8XC251Sx (8XC251SA, SB, SP, SQ) SPECIFICATION UPDATE

Release Date: September, 1996

Order Number 272836-003

The 8XC251Sx may contain design defects or errors known as errata. Characterized errata that may cause the 8XC251Sx's behavior to deviate from published specifications are documented in this specification update.

Figure 1. External Code Fetch, Nonpage Mode

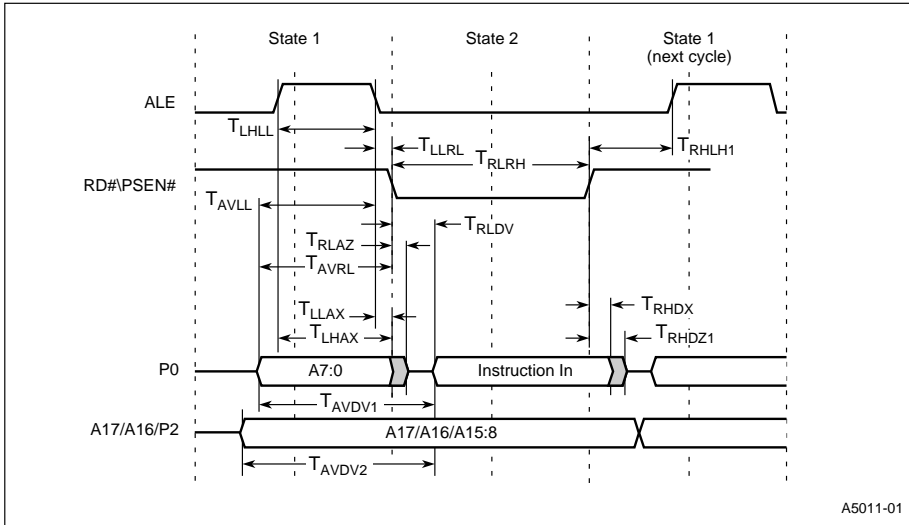
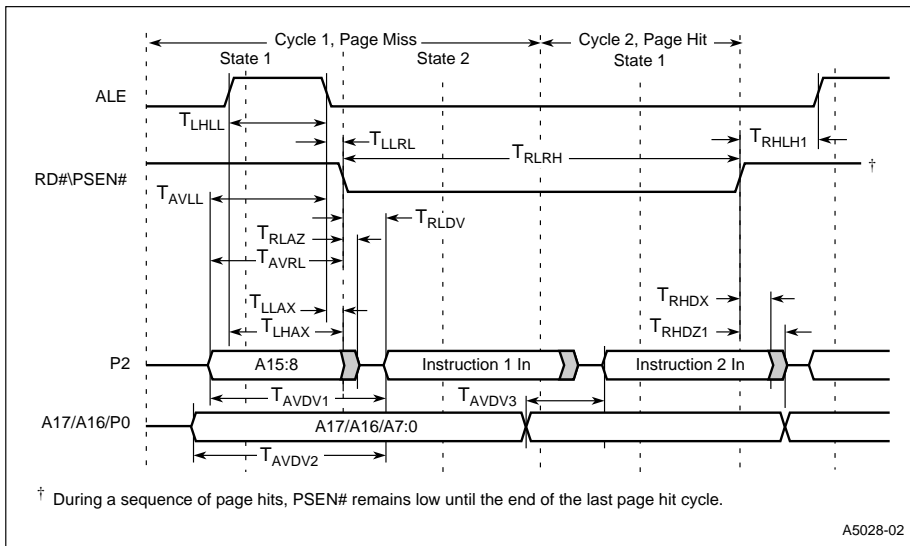
PROBLEM: The TRHDZ1 (Instruction Float After RD#/PSEN# High) specification on the 8XC251Sx when operating at 12 MHz is 10 ns. However, a slow memory device such as an EPROM typically takes approximately 30 – 90 ns to float its output. (This specification generically called TPHZ, may vary from one manufacturer to another.) Figure 1 and Figure 2 illustrate the TRHDZ1 timing.

The difference between the TRHDZ1 and TPHZ specifications causes contention on the data bus (P0 in nonpage page, P2 in page mode). The 8XC251Sx begins to drive the address for the next bus cycle while the memory device is still driving data from the previous bus cycle.
